**Town of Ruston**

**ORDINANCE 1319**

**AN ORDINANCE of the Town of Ruston relating to the approval and modification of the Ruston Landing Master Development Plan, regarding an application made by the Commencement Group, LLC.**

**Planning Commission Findings and Recommendation**  
**Commencement Condominium Proposal to Amend the**  
**Ruston Landing Master Development Plan**  
**MDP 09-01**

# COMMENCEMENT SITE PLAN

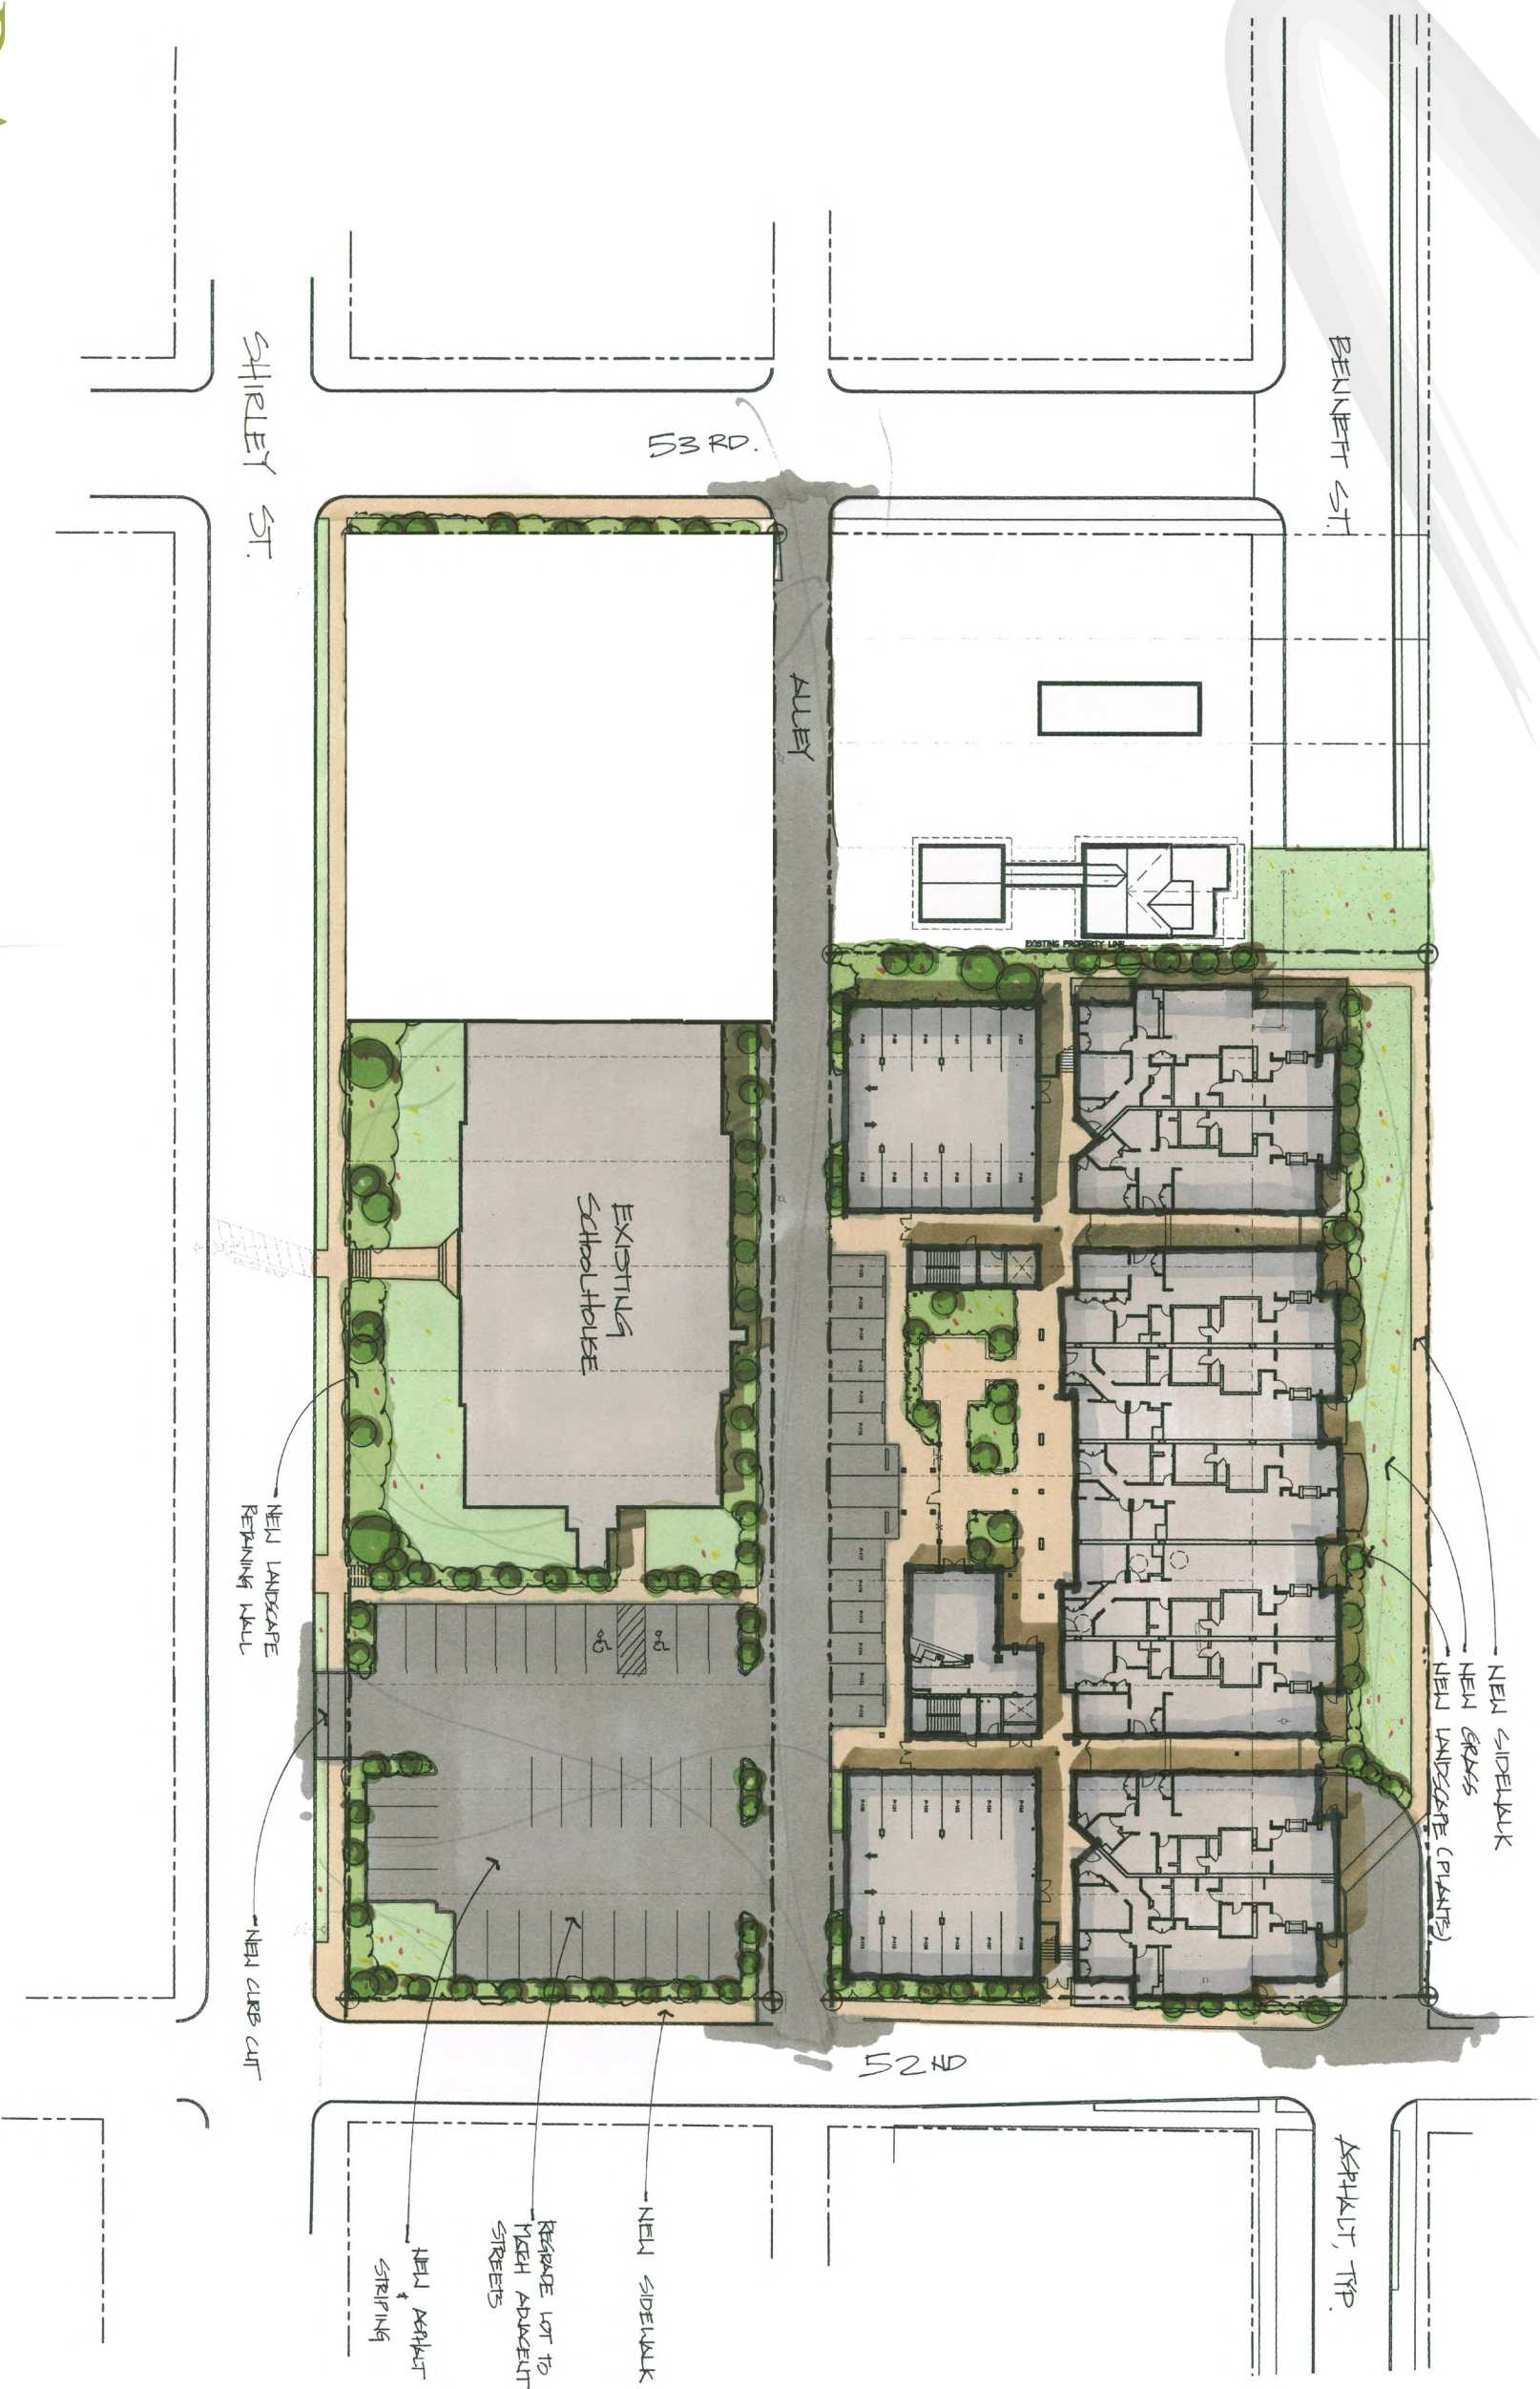
**Finding:** The Planning Commission finds that the minor amendment and real estate amendment portions of this proposal comply with this requirement. However, the Bennett Street Reconnection, OCF Park, and Public Parking Amendments do not. The application materials do not adequately address this issue. The applicant has not provided adequate evidence that parking lot paving, site landscaping, and window painting to the Town owned School Building will provide equitable public benefit to the existing requirements of Ordinance 1155, and the Ruston Landing Master Development Plan. The Planning Commission finds that this proposal would provide substantially inferior public benefit.

**Finding:** The Planning Commission finds that the minor amendment and real estate amendment portions of this proposal comply with this requirement. As stated above, the Bennett Street Reconnection, OCF Park, and Public Parking Amendments do not. The application materials do not adequately address this issue. The applicant has not provided adequate evidence that parking lot paving, site landscaping, and window painting to the Town owned School Building will provide equitable public benefit to the existing requirements of Ordinance 1155, and the Ruston Landing Master Development Plan. The Planning Commission finds that this proposal would provide substantially inferior public benefit.

**Finding:** The Planning Commission finds that the minor amendment and real estate amendment portions of this proposal comply with this requirement. As stated above, the Bennett Street Reconnection, OCF Park, and Public Parking Amendments do not. The application materials do not adequately address this issue. The applicant has not provided adequate evidence that parking lot paving, site landscaping, and window painting to the Town owned School Building will provide equitable public benefit to the existing requirements of Ordinance 1155, and the Ruston Landing Master Development Plan. The Planning Commission finds that the proposal is in direct conflict with this requirement as it proposes to eliminate public view access, parking and recreational facilities which were specifically required as part of the original proposal.

The Planning Commission recommends that the Town Council approve the minor amendments as described in section II of this report as proposed, subject to the following condition:

- A) No further amendments to the master development plan shall be permitted, regardless of whether they are minor or substantial, without Town Council approval.
- B) The applicant shall provide the Town with final "as-built" drawings prior to final occupancy.

The Planning Commission recommends that the Town Council approve the previously negotiated real estate amendments as described in section II of this report as proposed, subject to the following condition:

- C) Prior to final occupancy, the applicant shall provide the Town with a revised site plan reflecting any changes approved through this amendment proposal.

The Planning Commission recommends that the Town Council modify the master development plan to include the following condition:

- D) The applicant shall reconstruct the Bennett Street road segment between 52nd and 53rd streets, including all associated parking and open space, as approved in the original Ruston Landing Master Development Plan, and as further detailed on the building permit for the Commencement Condominium Building, and also as specifically required by Ordinance 1155. Alternatively, the applicant may propose a substitute improvement so long as it provides equitable value in terms of financial, aesthetic, recreational, and functional value to the Town. Any proposal to provide a substitute improvement shall be submitted to the Town Planner in writing and be accompanied by the following, prior to Town Council consideration:

- E) The applicant shall provide the Town with final "as-built" drawings prior to final occupancy.
